MODIFICATIONS TO THE TUBE-LAUNCHED, OPTICALLY
TRACKED, WIRE-COMMAND MISSILE LAUNCHER FOR
THE BRADLEY FIGHTING VEHICLE SYSTEM

Report Number 98-165

June 25, 1998

Office of the Inspector General
Department of Defense

Figure 3. Umbilical Switch Specification

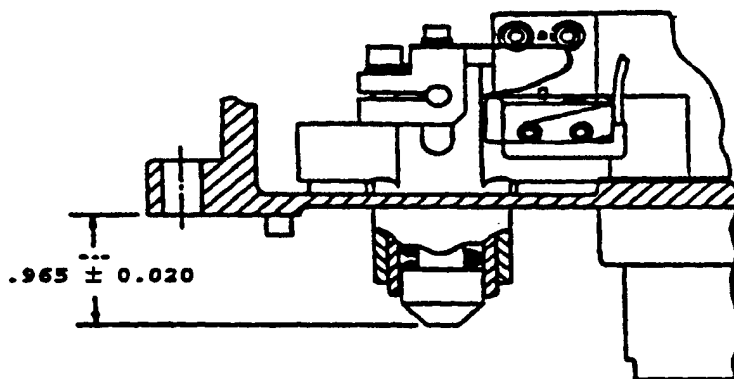
Alignment of Umbilical Switches. The DMWR requires the gauge set to align and test the ACU umbilical switches S1, S2, S3, and S4. Switches S1 and S2 are associated with the inboard launcher tube, while S3 and S4 are associated with the outboard launcher tube. The S2 and S4 switches, when activated, signal that a missile is present. The S1 and S3 switches, when activated, signal that a missile has been selected. According to the design specifications, those umbilical switches should be aligned to activate when the bottom of the holdback pin plunger is 0.965 inches, plus or minus 0.020 inches, from the bottom of the ACU housing as shown in Figure 3.

The S1 through S4 gauge assembly of the gauge set is used to measure the depth of the holdback pin plunger at the time the umbilical switches have been activated.

Figure 4. Holdback Pin Plunger Depth Specification

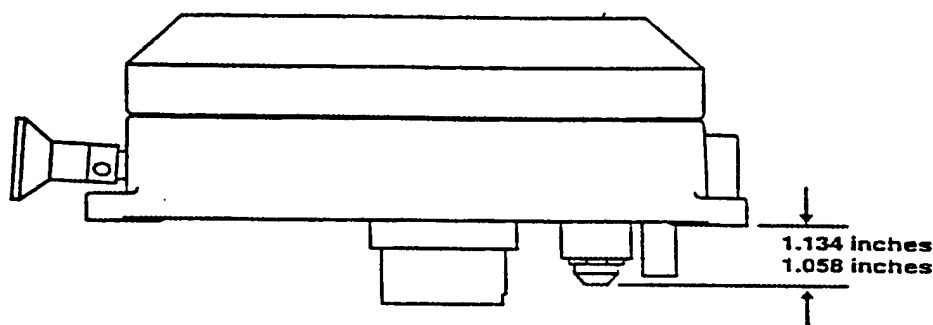
Alignment of Motor Stop Switches. The DMWR requires the gauge set to align and test motor stop switches S5 and S6. The S5 switch is the electrical limit switch for the extend function of the ACU motor. The S6 switch is the electrical limit switch for the retract function of the ACU motor. The S5 and S6 settings affect the distance that the holdback pin plunger and umbilical cable are extended when arming the system and retracted when disarming the system. The gauge set, specifically the S5 gauge assembly is required to ensure that the holdback pin plunger depth in relation to the ACU housing is between 1.058 inches and 1.134 inches, as shown in Figure 4, in order to satisfy design specifications.

Figure 5. Setscrew Adjustment Gauge

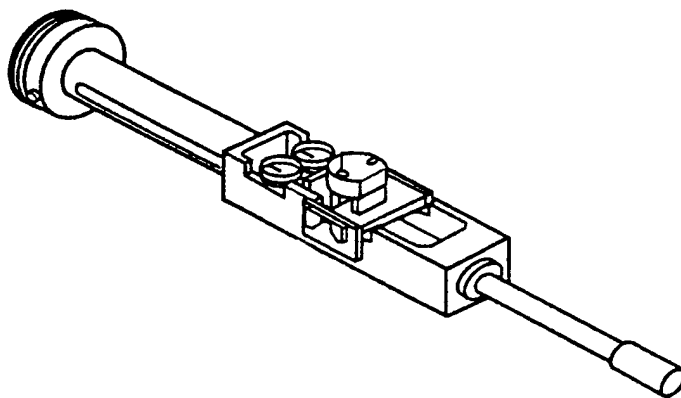
Setscrew and Stop Block Adjustments. A setscrew adjustment gauge, part 12295912-40101-5 (shown in Figure 5), is required to perform the setscrew

and stop block adjustments to ensure that they meet the design specifications. The setscrew is to be set between -0.0005 inches and 0.0005 inches; and the stop block is to be set between 0.002 inches and 0.001 inches.
